HISTORIC PRESERVATION REVIEW BOARD STAFF REPORT AND RECOMMENDATION

Landmark/District: Mount Pleasant Historic District (x) Agenda Address: 3205 19th Street NW (x) Permit

Case Number: 23-569

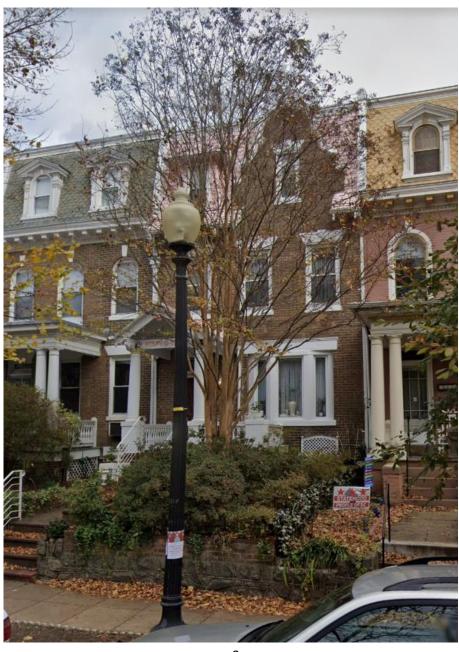
The applicants have suggested that a basement entrance would not be visible from the street, but that is not the case. The front retaining wall reaches at a maximum height above the sloping sidewalk of 35 inches at the south corner (see photo below), and the slope of the yard behind it is gentle. A first glance may deceive because of plantings, but much of these would have to be removed for the excavation and the extension of the walk. An entrance from the rear yard is more compatible, and the houses on the row generally have such entrances.
